PETITION NO: Z-24

PROPOSED USE: Single-Family
Subdivision

Planning Staff Analysis

Z-24

REVISED
 RECEIVED
 JUN 16 2011
 COBB CO COMM DEV AGENCY
 ZONING DIVISION
JWC 6-20

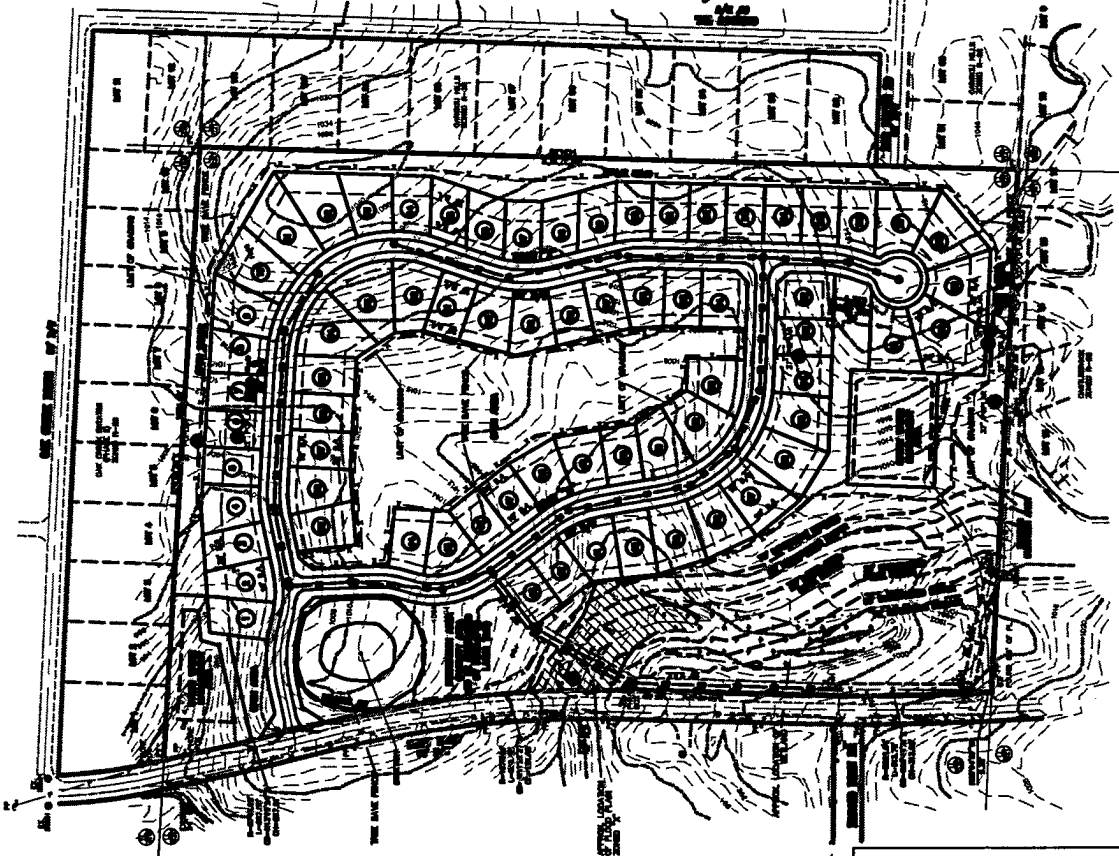
1. Both detention ponds must be located on separate parcels with adequate direct access from the public right-of-way. The northern most detention pond is located directly adjacent to a neighboring existing residential subdivision. Adequate landscaping must be provided to screen this pond from the existing residences.

1. Overall residential development shall be compatible with neighboring residential uses. Submitted, revised site plan received on June 16th shows typical lot sizes of 6,500 sf. Consider increasing lot sizes to be more attuned to neighboring residential uses which range from 14,000 sf. in Castelbrooke to 24,000 sf. in Caribou Hills to the east. Mitchell Falls, a 7 unit Conservation Subdivision (CS) across Shaw Road, contains typical lots sizes around 8,700.

2. No portion of floodplain, wetland area, cemetery or impervious community areas may be used in calculating density. Need to subtract wetlands, cemetery and any impervious community or recreation areas from overall acreage in calculating density. Since the documented floodplain is Zone X or 500 yr. flood, it can be included as part of the overall development density calculation.

3. Recreation Area must be constructed with pervious material since it is calculated as part of open space.

4. Stormwater management areas need to be identified as structural or non-structural. If stormwater management area is structural then it can not be calculated within open space and be subtracted from total open space area.

5. Wetlands can only account for 75% of required open space. The total wetland area is approximately 8% of required open space so entire wetland area can be calculated within open space. Because Floodplain is Zone X or 500 yr floodplain there is no need to include it as part of the 75% requirement.
